CSB-1109-2 Country : UK Date : 11/13/2006 APC : ALL Repair Level : 2

Title Model Effected

V3V3 05 CR - GSM - Speakerphone Metallic FM V3 & V3\_05

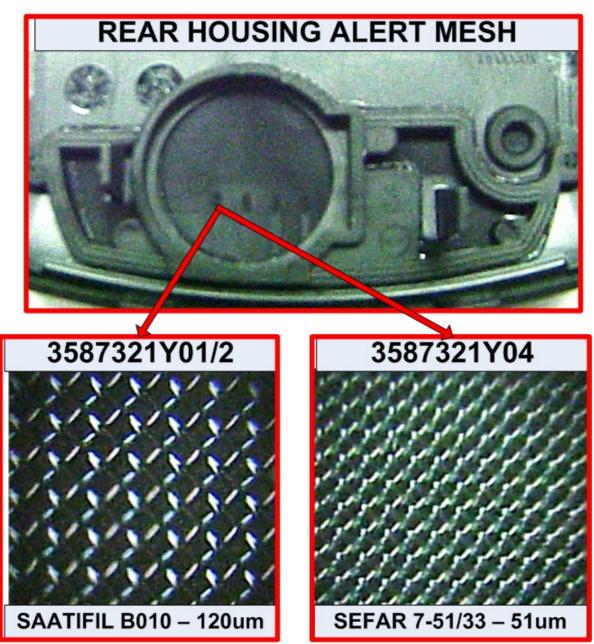
Service has been made aware of a Razr GSM (V3 & V3\_05) speakerphone distortion issue causing "Alert" complaints.

The root cause of the distortion is metallic debris found on the speakerphone which was introduced in the field.

To improve the FM ingression from the rear housing mesh to the speaker phone, the pore size of the mesh was reduce from 120um (micron) to 51um.

The part number change from 3587321Y01/2 to 3587321Y04.

After servicing any Razr GSM (V3 & V3\_05) customer phones with described issue replace the speakerphone and the rear housing with the new mesh if available. Speakerphone part number: 5088017N02

Rear Housing part number: 1590048Nxx
